<b>Docket Number:</b>	79-AFC-04C
<b>Project Title:</b>	Compliance - Application for Certification of DWR Bottlerock Geothermal Project
<b>TN #:</b>	268605
<b>Document Title:</b>	Bottle Rock Overall SLD
<b>Description:</b>	Overall SLD for the project.
<b>Filer:</b>	John C Casteel
<b>Organization:</b>	Mayacma Geothermal LLC
<b>Submitter Role:</b>	Applicant
<b>Submission Date:</b>	2/12/2026 3:47:33 PM
<b>Docketed Date:</b>	2/12/2026

MAYACMA GEOTHERMAL LLC  
REPOWER PROJECT

OVERALL ONE-LINE  
DIAGRAM

SHEET NO:	E-1001	REV:	B
-----------	--------	------	---

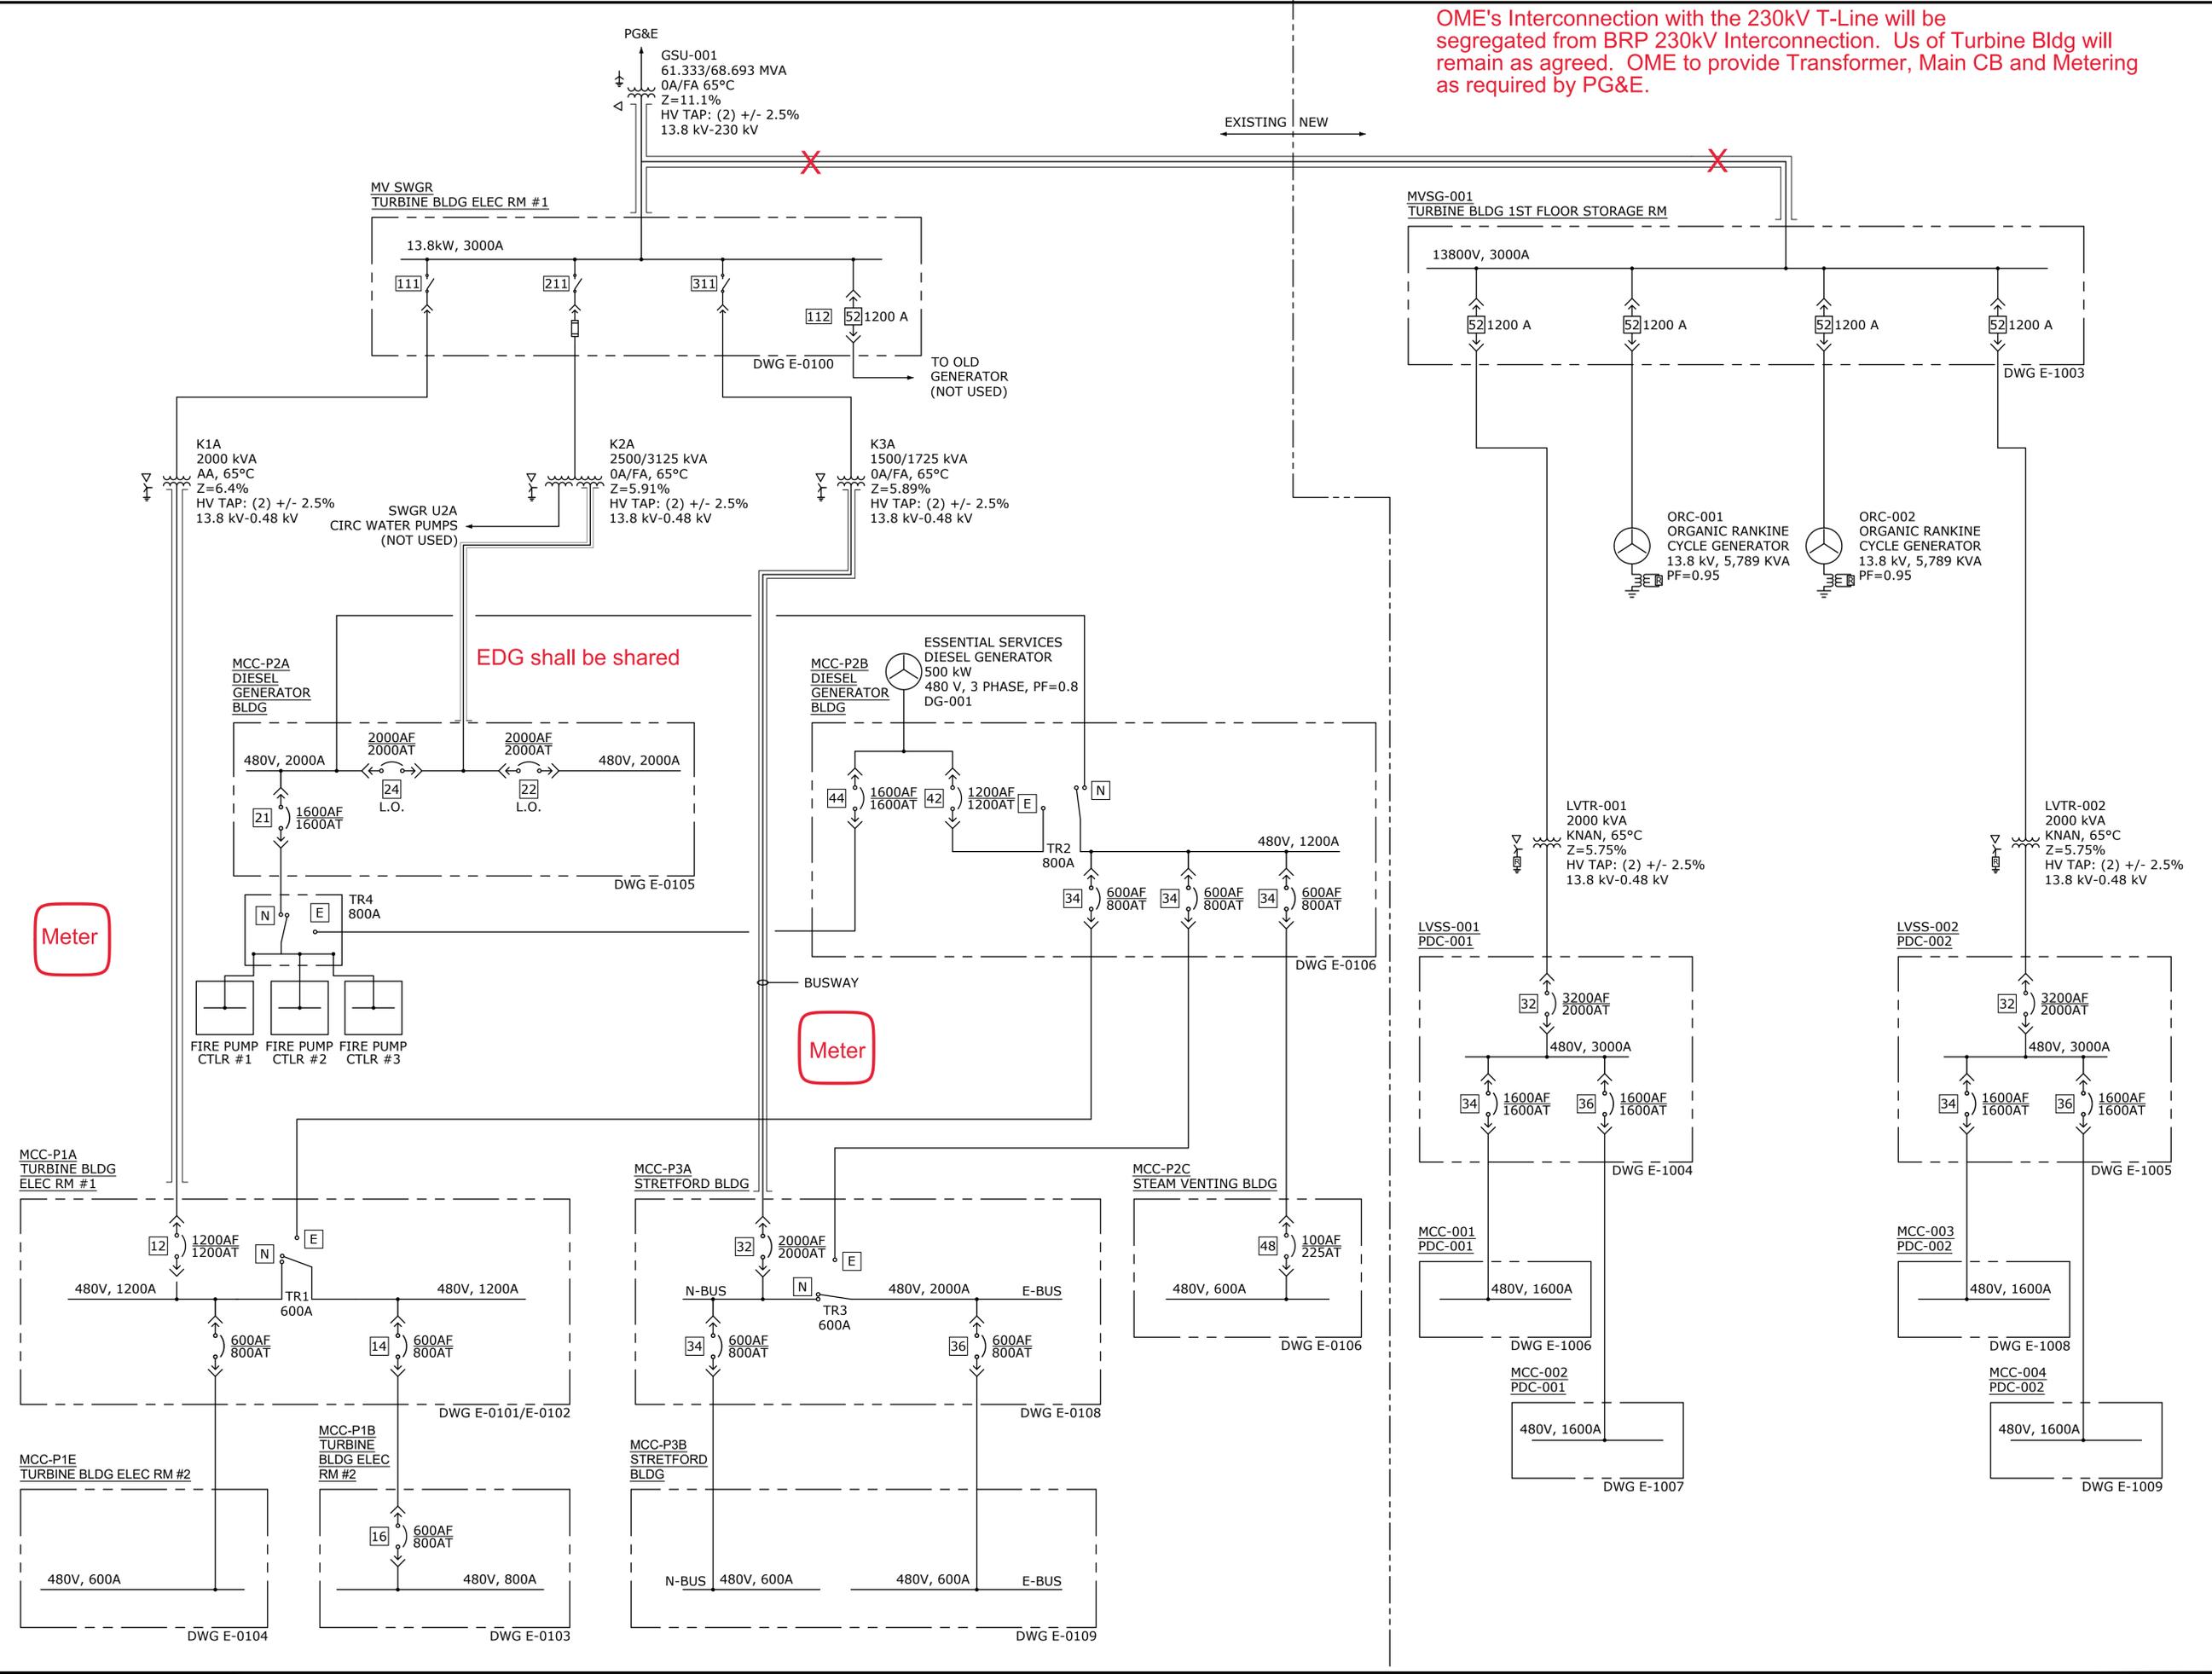
OME's Interconnection with the 230kV T-Line will be segregated from BRP 230kV Interconnection. Us of Turbine Bldg will remain as agreed. OME to provide Transformer, Main CB and Metering as required by PG&E.
